PUBLIC INTEREST REVIEW FOR GROUNDWATER APPLICATIONS

TO: Water Rights Section Date June 13, 2016  
 FROM: Groundwater Section Michael J Thoma  
Reviewer's Name  
 SUBJECT: Application G- 18265 Supersedes review of \_\_\_\_\_  
Date of Review(s)

**A. GENERAL INFORMATION:** Applicant's Name: Rogue River Trust County: Josephine

A1. Applicant(s) seek(s) 0.11 cfs from 1 well(s) in the Rogue Basin,  
Williams Cr subbasin

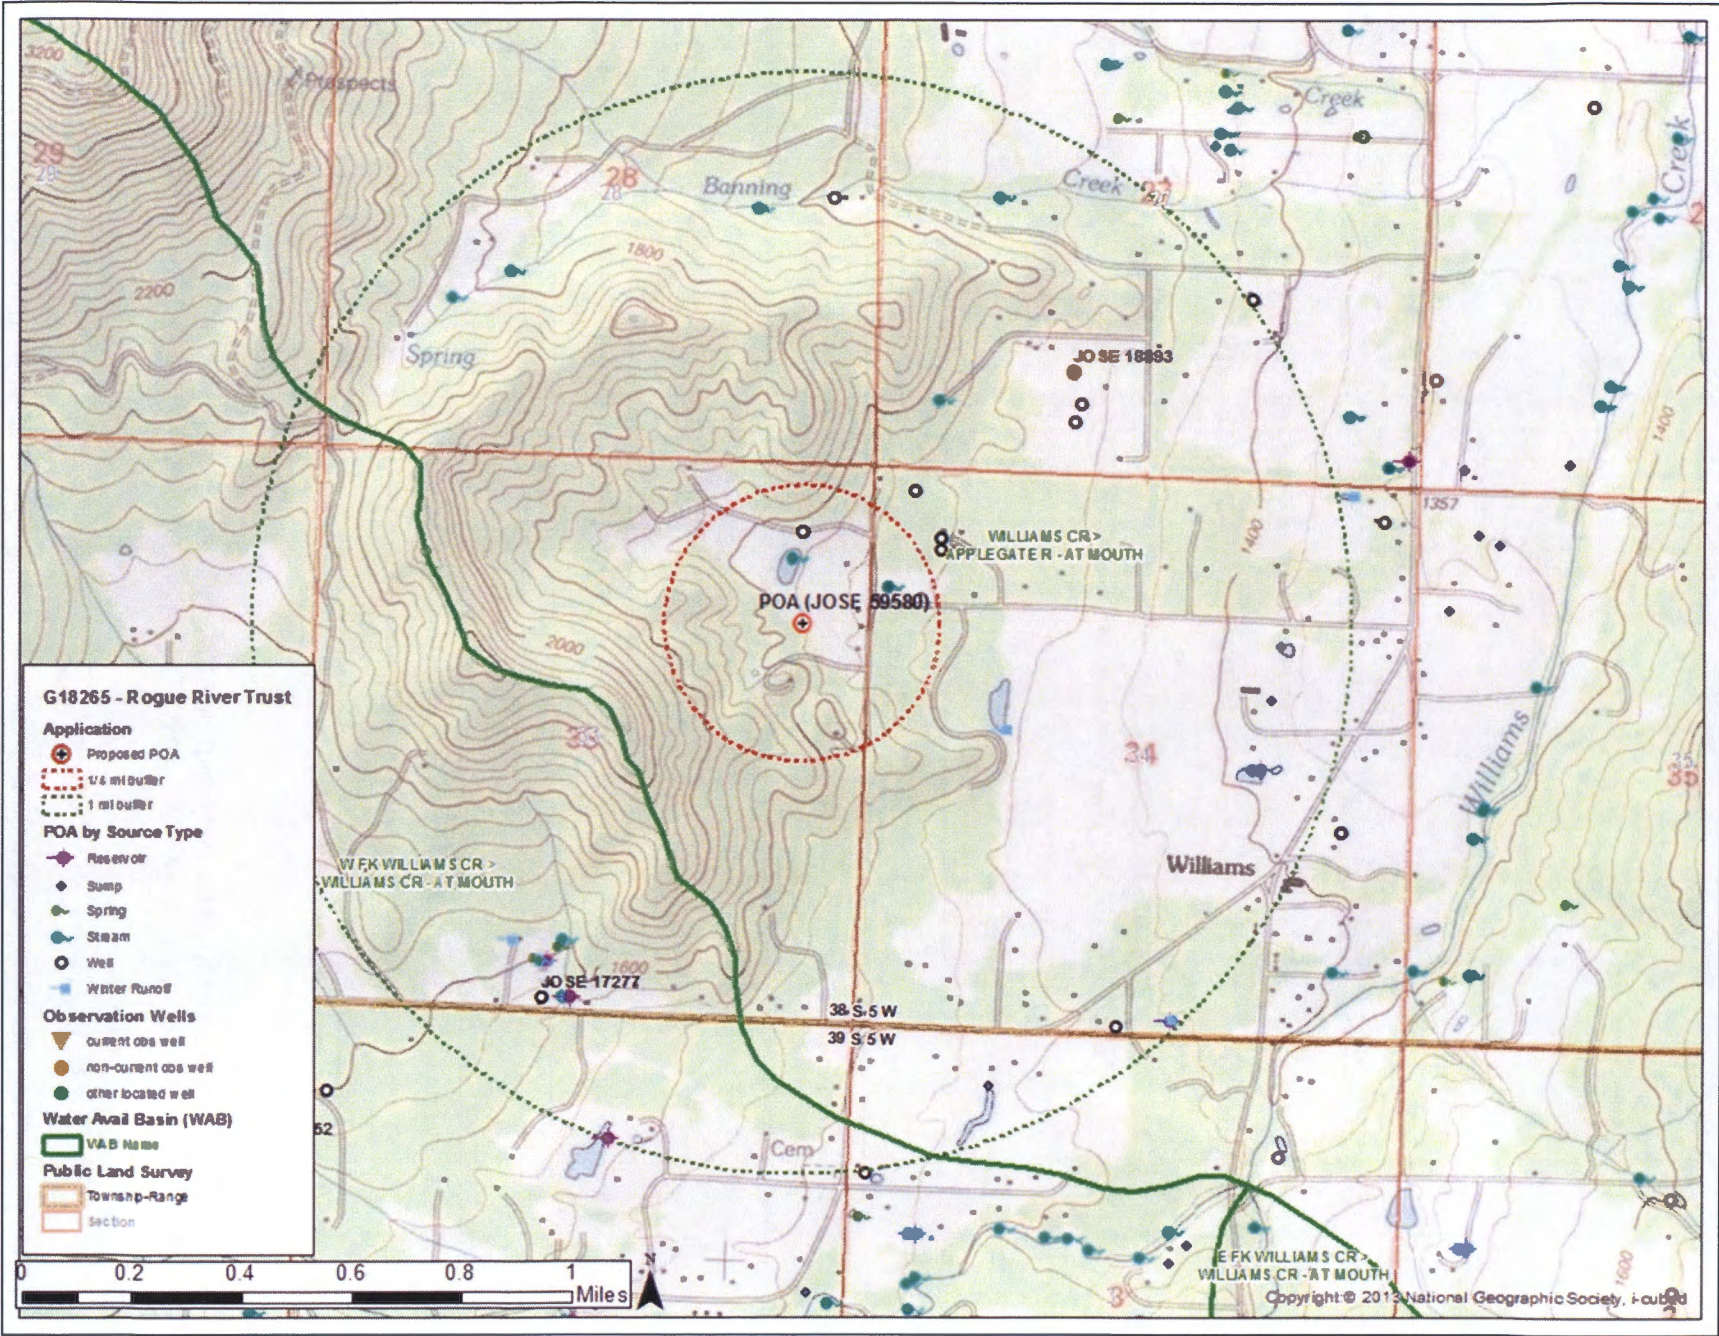
C6. **SW / GW Remarks and Conditions:** The applicant's proposed POA would be producing from an aquifer that has been found to be hydraulically connected to Williams Cr and Banning Cr. However, the Department is unable to determine impacts to either streams and so cannot assume that the proposed use will have the Potential for Substantial Interference.

**Banning Creek:** The ridge between the proposed POA and Banning Cr is likely also a local groundwater divide which would significantly reduce the efficiency of hydraulic connection between the proposed POA and the nearest point on Banning Cr. Furthermore, the higher GW elevation induced by the ridge to the west of the proposed POA would warp the cone of depression caused by pumping by shortening it to the west and extending it to the east; thereby further pushing the point of hydraulic connection farther downstream on Banning Cr.
